CONSULTANT ADVICE

Project Name	Wilson Street Chatswood	Project #	230368
Subject	Pit Depth Requirements	Revision	JHA CAN-VT001 17/07/2025

Figure 1: Section view of pit space for lift pits ≤ 2.5 m

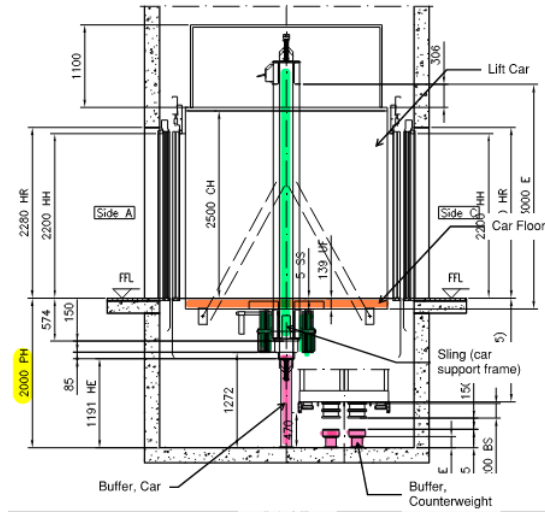
The pit is the space in the liftwell between the bottom floor served and the liftwell floor. There are mechanical components fixed there and provides mechanical clearance for components located under the lift car floor see **Figure 1**.

Figure 2: Section view of pit space for pits > 2.5 m

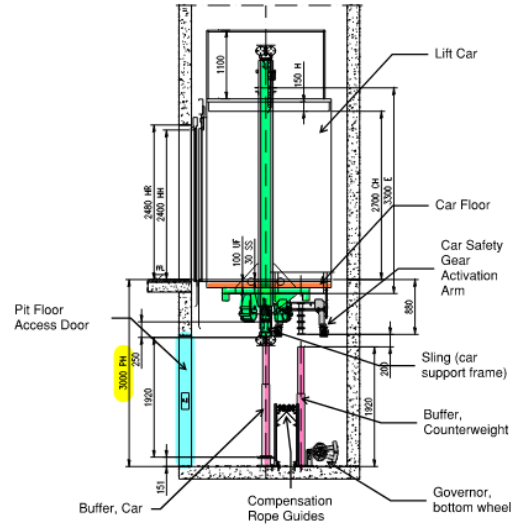
Most low-rise and medium rise buildings with lifts have a pit depth range 1.0-2.5 m which is suitable for lifts with speeds ≤ 2.5 m/s. High-rise buildings have faster lifts, > 2.5 m/s, consequently those lifts require deeper pits, > 2.5 m, to accommodate larger components or additional components, see **Figure 2**. Pit depths > 2.5 m pose a hazard to installers and maintenance staff when using the pit ladder to reach the pit floor from the bottom landing. In these instances, the lift design standard has a requirement that a pit floor access door be provided, see **Figure 3**, instead of using pit ladder from the bottom floor served, see **Figure 4**, EN 81-20:2020 Cl 5.2.2.4 b), this also means an access way and stairway will be required comply with AS 1657.

Figure 3: Example of pit access for lifts with pit depths > 3.0 m

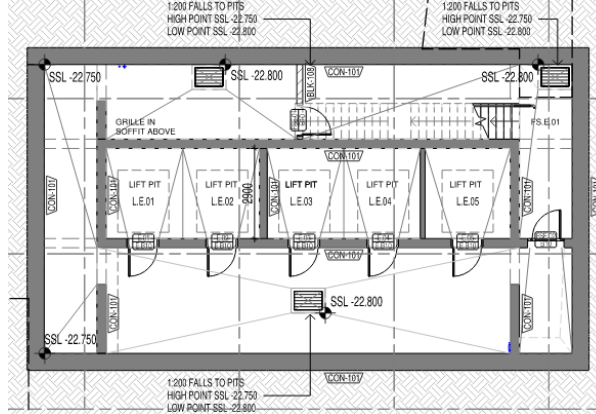
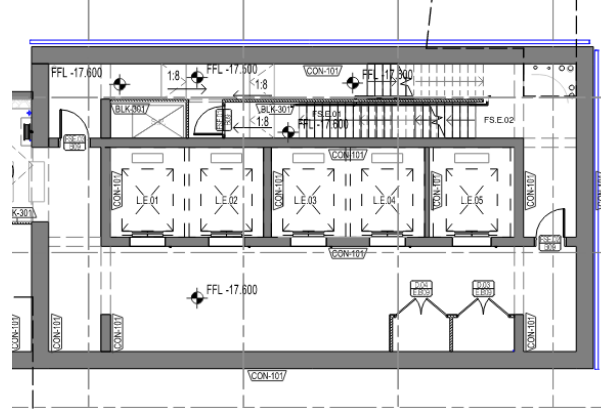
These lifts require a lift speed of 3.0 m/s to achieve a good level of lift performance, consequently, a deeper pit is required to comply with the lift design standard (AS 1735.1.1 / EN 81-20) which means a pit floor access door is required. The area referenced as the 'lift plant room located on Basement 7' is part of the access way to the lift pit floor, no components or machinery will be located in this area, only inside the liftwell. Note that the motor and controller are located in the headroom, the upper space in the liftwell between the top floor served and the underside of the liftwell lid. Therefore, the area outside of the liftwell is not the lift plant room.
